# City of Santa Fe, New Mexico

# memo

2025-011328-HDRB, 433 Calle La Paz, Downtown & Eastside Historic District, contributing, Martinez Architecture Studio PC, agent for The John C. Gregory Revocable Trust and the Pamela S Austin Revocable Trust, owners, proposes to replace windows and doors, vigas, install wood railings, exterior stairs with hand rails, and construct a 210 sq. ft. portal to a height of 10'-6" on the main residence, install 5'-0" high fencing, and construct at 148 sq. ft. portal to a height of 11'-5", replace windows and doors, and install an overhang on the casita, and refinish the garage door. An exception is requested to 14-5.2(D)(5)(a)(i) for replacing historic windows.

Figure 8: Façade Diagram

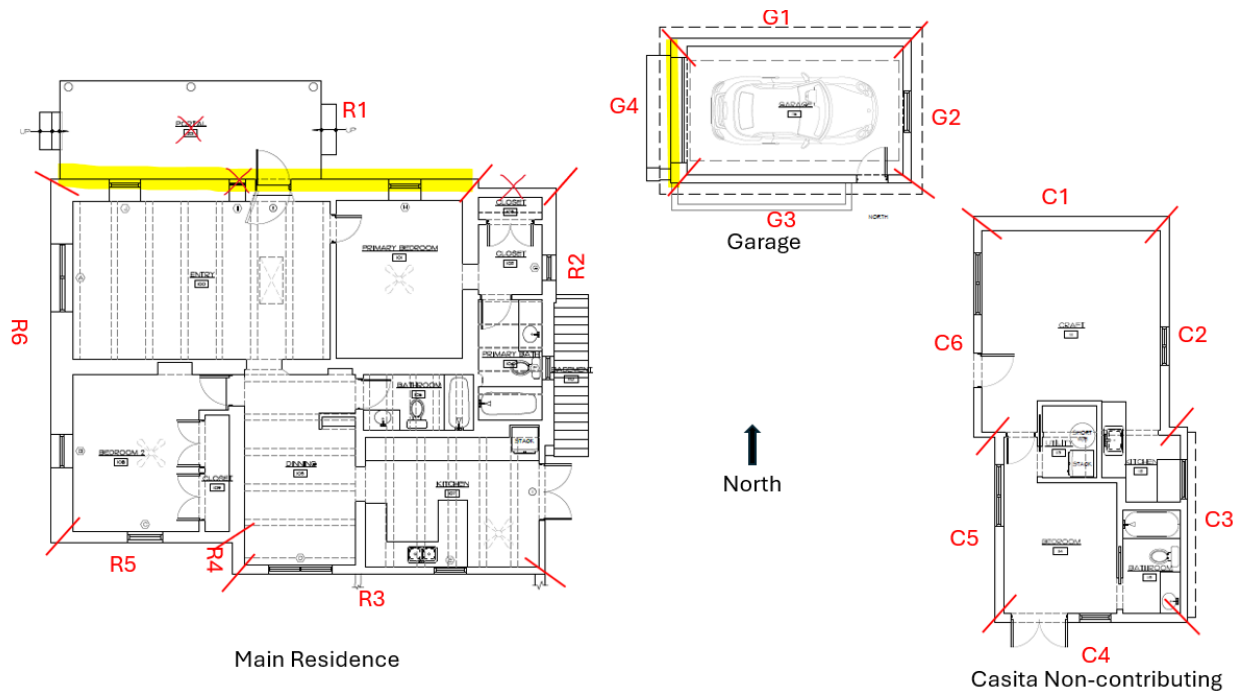
2025-010839-HDRB the Board was to maintained the main residential structure's contributing status and designated the north (R1) as the primary facade excluding the portal which appears to be new based on the HCPI that refers to non-weathered wood and a new flooring and decking, the sidelite window which per the HCPI is likely not original, and excluding the eastern addition wall which has no coping unlike the rest of the house, designated the garage as contributing with the west (G4) as the primary facade, and designated the guesthouse and yard walls as non-contributing due to their age.

Figure 9: Window Schedule

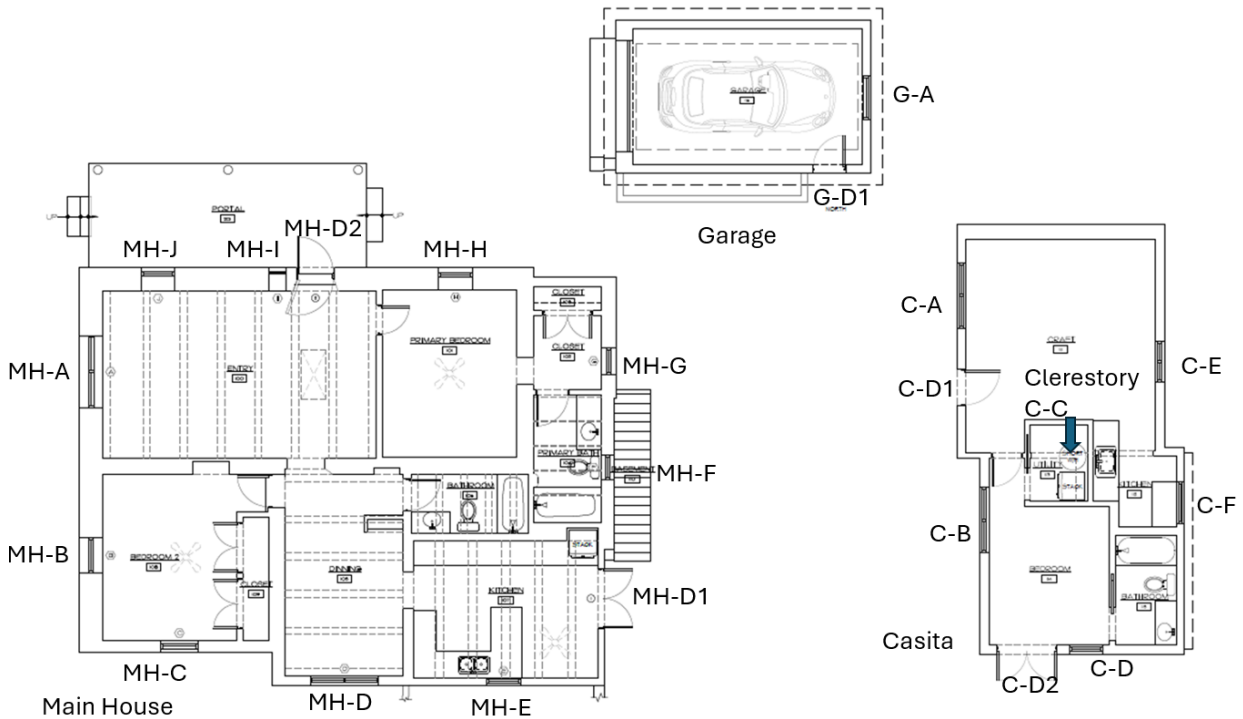
1. Replace windows and doors. An exception is requested to section 14-5.2(D)(5)(a)(i) to replace historic windows on a primary façade. The windows will be replaced with double-pane wood windows with divided lites, and sizes to match the existing windows.
  - a. North
    - i. Window MH-H 32”x 64” Double Hung
    - ii. Window MH-J 29”x 48” Double Hung
    - iii. Window MH-I14”x 51” fixed (excluded from the primary façade designation).
  - b. West
    - i. Window MH-A 71”x 38” fixed barn sash
    - ii. Window MH-B 32” x 64” Double Hung
  - c. East
    - i. Window MH-F 26” x 32” double hung 2015 clad
    - ii. Window MH-G 21” x 31” fixed barn sash

- iii. Door MH-#1 wood frame door 60" x 81" clad 2015 will be replaced with a wood sliding divided lite door.

Staff Response: Staff finds that this criterion is met. The replacement windows will appear in kind and will not damage the character of the district.

Staff Response: Staff finds that this criterion is met. Per the window assessment: "Windows B & H and J are historic; however, there are signs of water penetration underneath the sills of the windows, causing structural integrity damage to the adobe. The windows would need to be removed to properly flash the openings to stop the water penetration. The window jambs are the buck in the openings. Removal of the window would destroy the jamb and cause the historic window to be non-reusable and non-restorable. Window G is historic; however, rotted beyond 40% and is non-restorable. Windows and doors A, C, D, E, DR #1, F, and I are non-historic." Replacing windows that allow water penetration is necessary to avoid further damage to the contributing building.
